MARTIN COUNTY, FLORIDA DEVELOPMENT REVIEW

STAFF REPORT

BARON LANDINGS PLAT

Report Number: 2024 0906 G076-011 Staff Report Final

Parcel Name: Access Parcel 1-A - Standard: 8

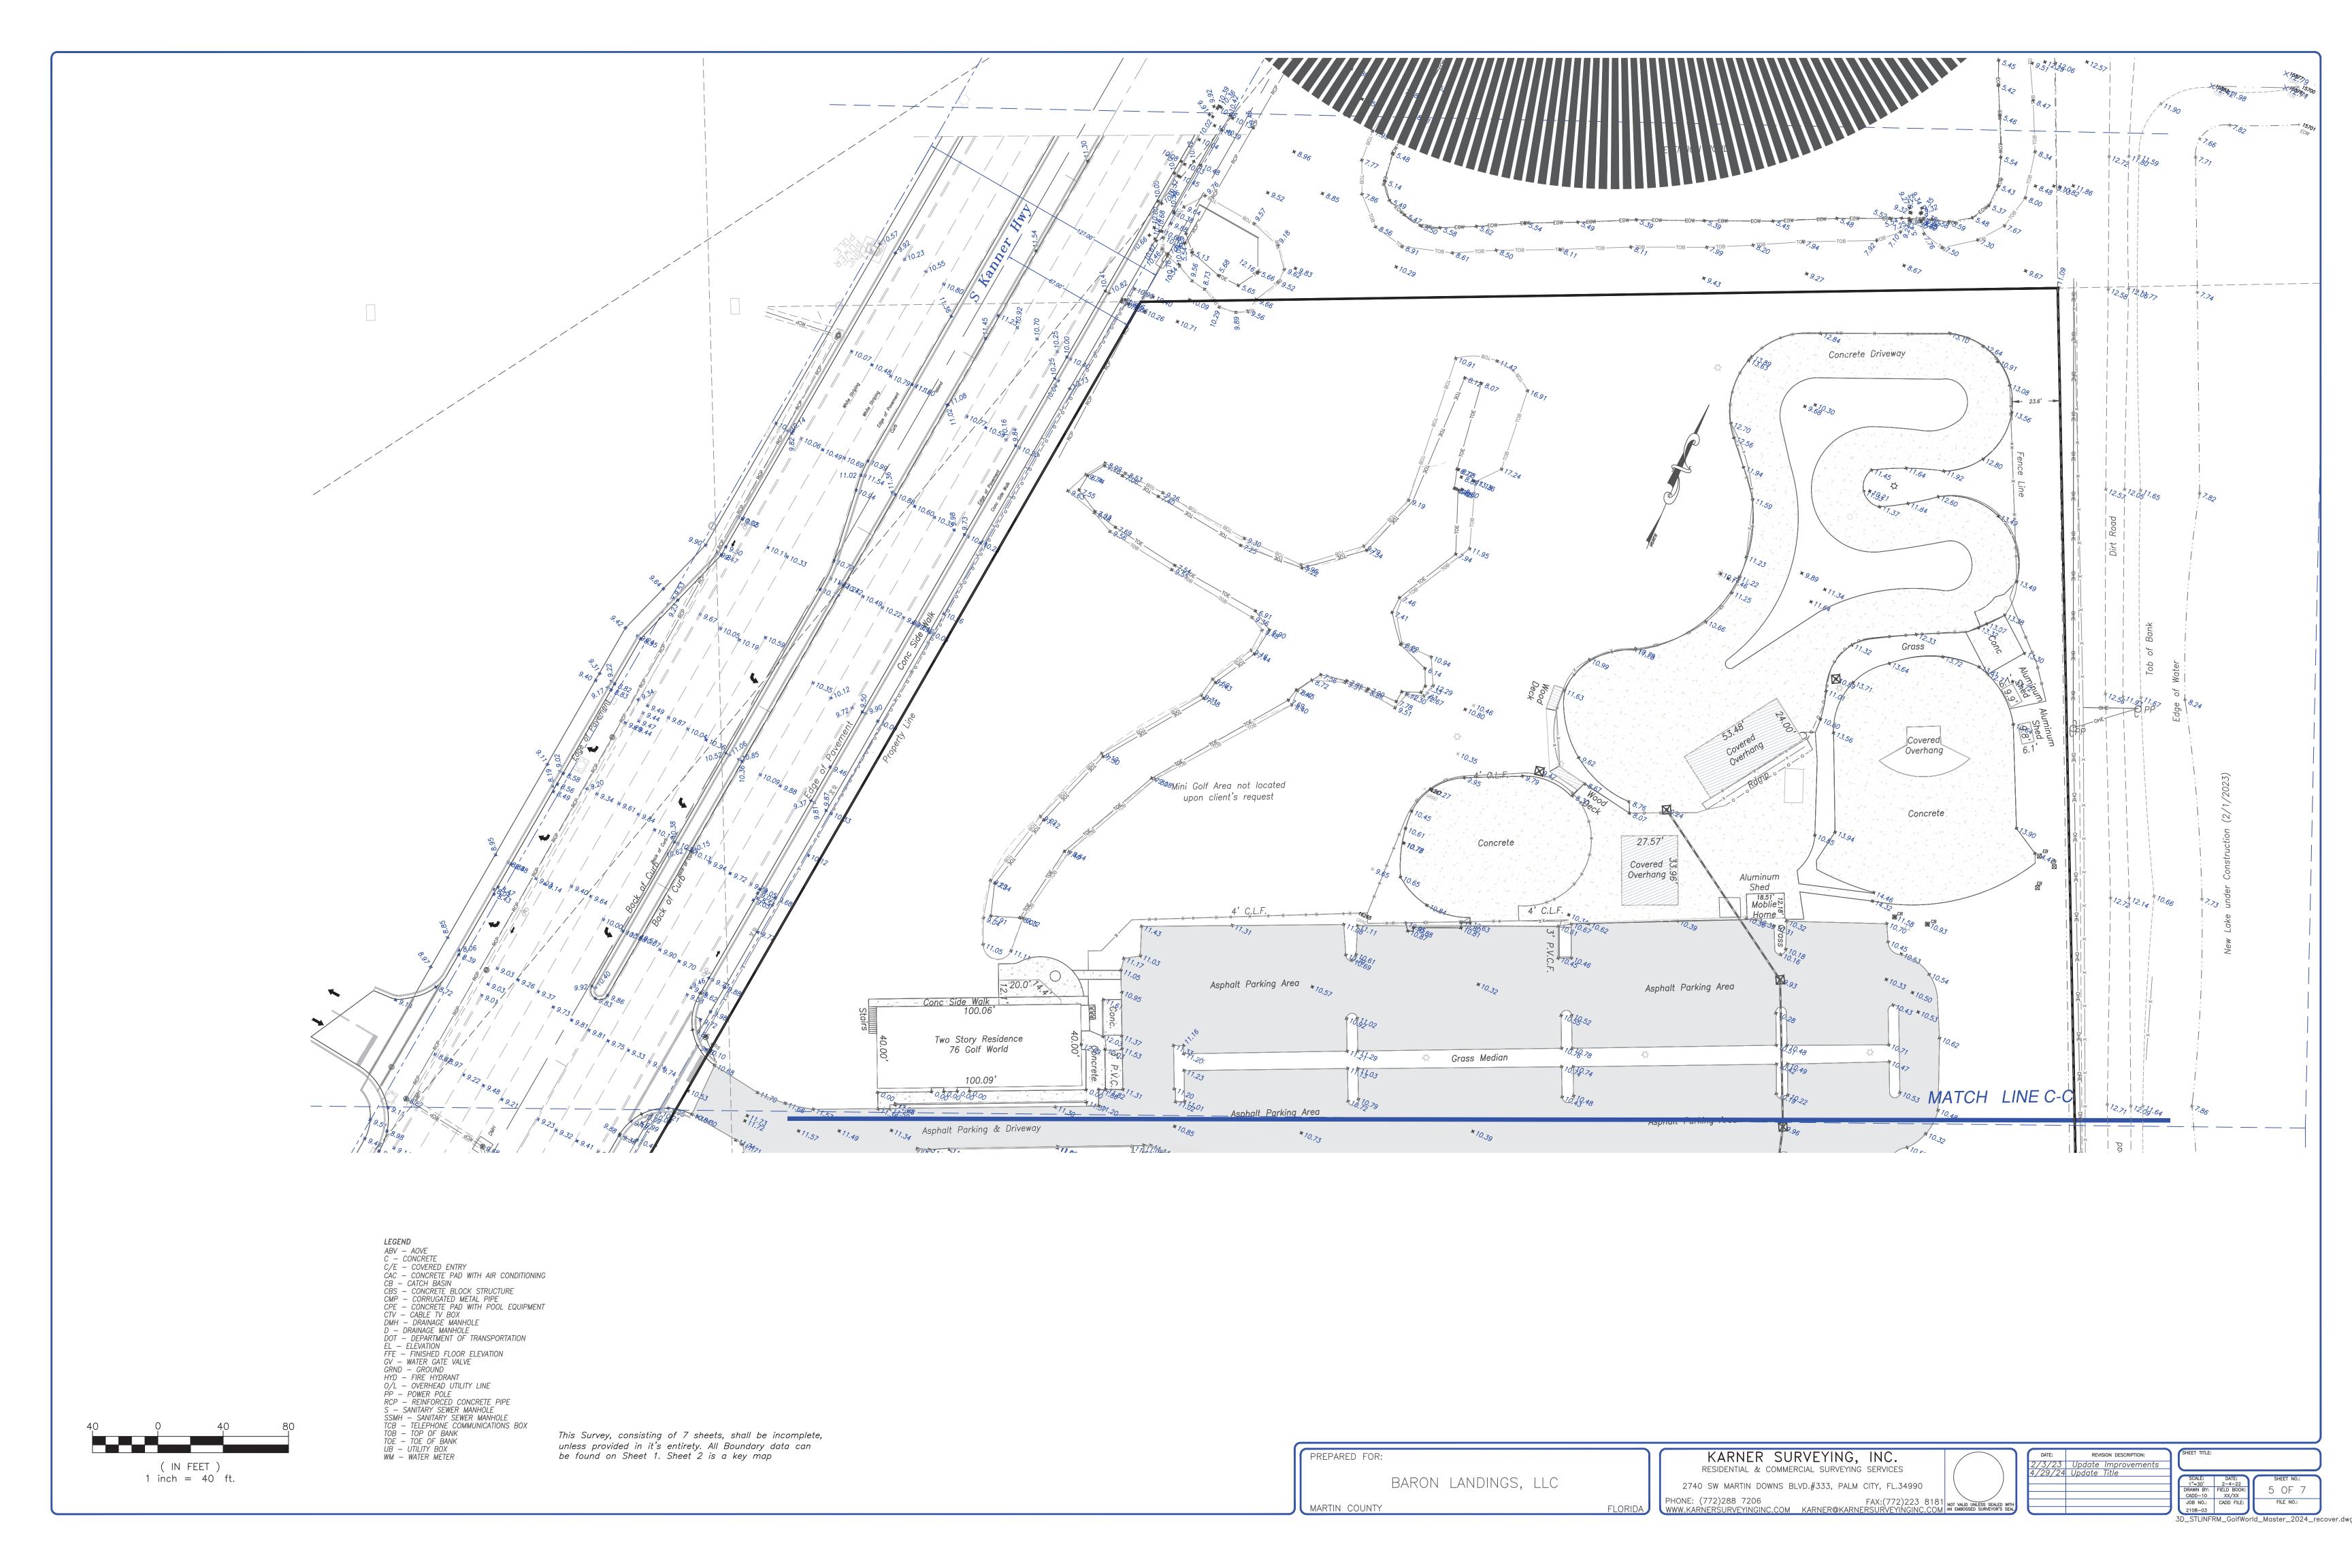
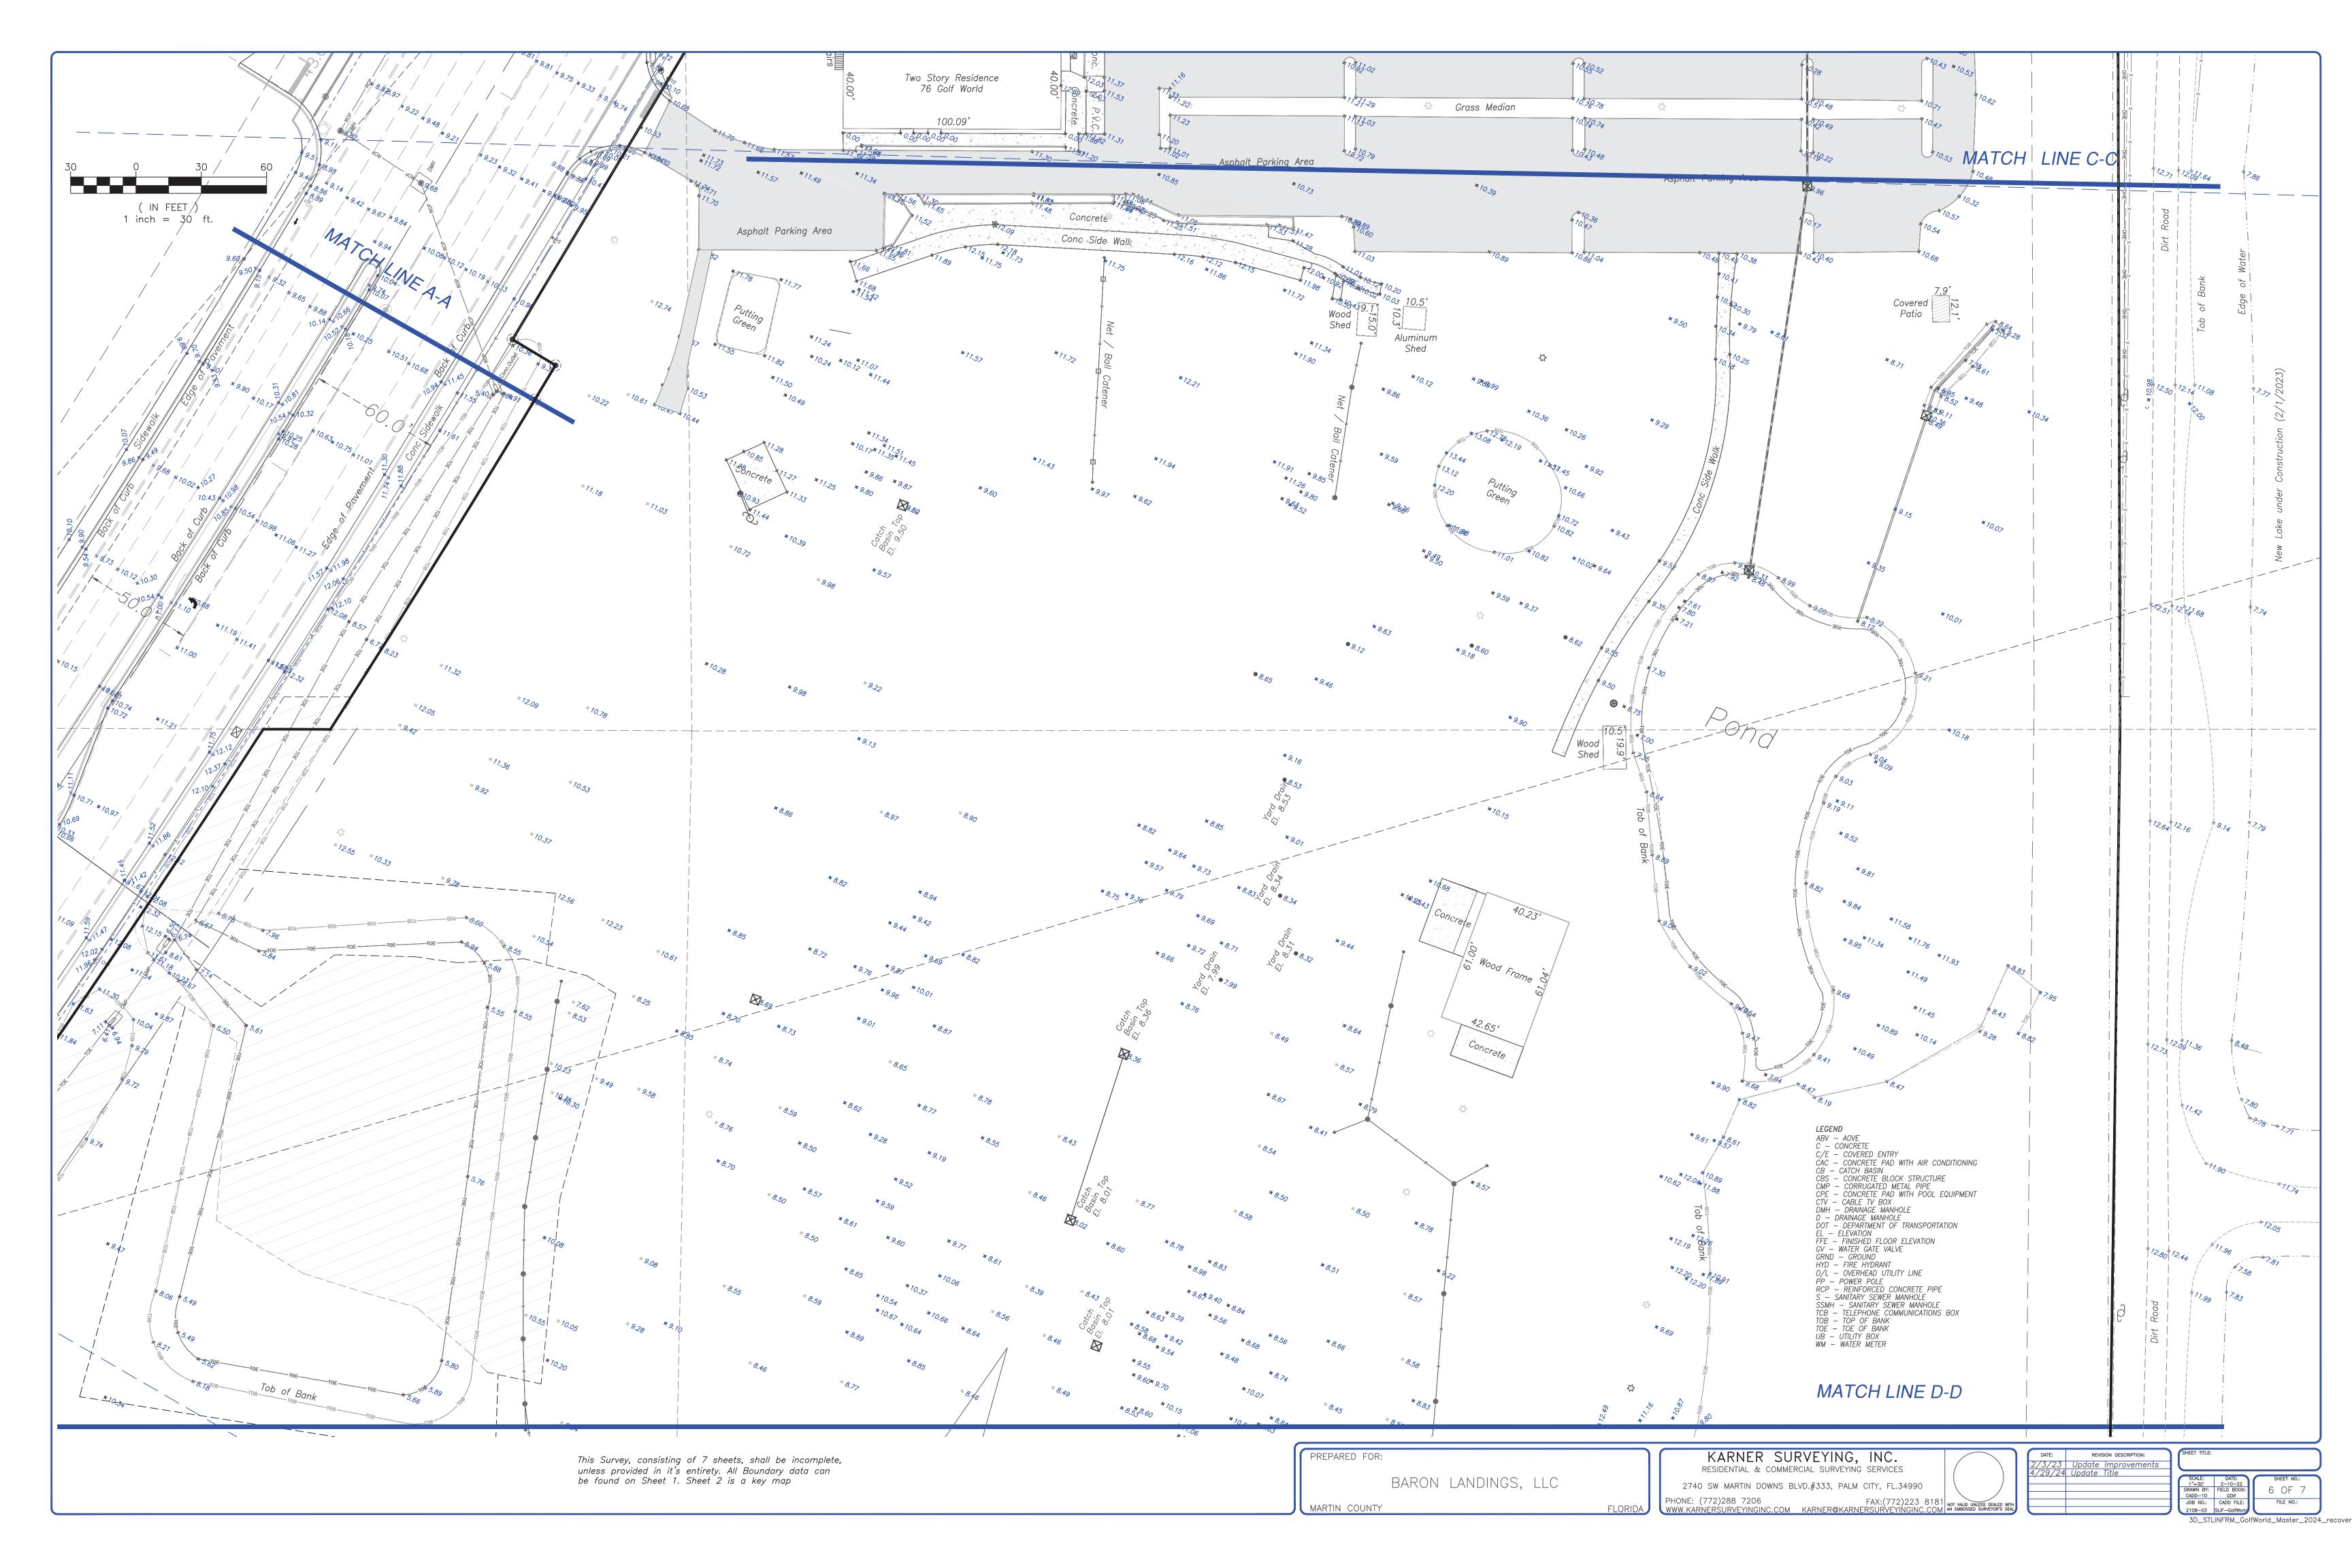
1.) PLEASE SEE COMMENT NOTATIONS INDICATING INCONSISTENCIES BETWEEN THE CLOSURE REPORTS AND THE PLAT.
2.) CORRECT THE INCONSISTENCIES BETWEEN THE OVERALL PLAT BOUNDARY CLOSURE REPORT, CORRESPONDING CLOSURE REPORTS AND WHAT IS LABELED ON THE PLAT.

MISSING LABEL ON SHEET 6 OF 6 OF PLAT

LABEL INCONSISTENCY ON SHEET 6 OF 6 OF PLAT

LABEL INCONSISTENCY ON SHEET 4 OF 6
OF PLAT

2.) PLEASE SEE COMMENT NOTATIONS INDICATING INCONSISTENCIES BETWEEN THE CLOSURE REPORTS AND THE PLAT.

MISSING LABEL ON SHEET 6 OF 6 OF PLAT

MISSING LABEL ON SHEET 4 OF 6 AND

- 1. Please see provided closure report mark-ups for inconsistencies between the closure report data and the data shown on the Plat.
- 2. New closure reports need to be submitted for all tracts and overall plat boundary with next submittal.
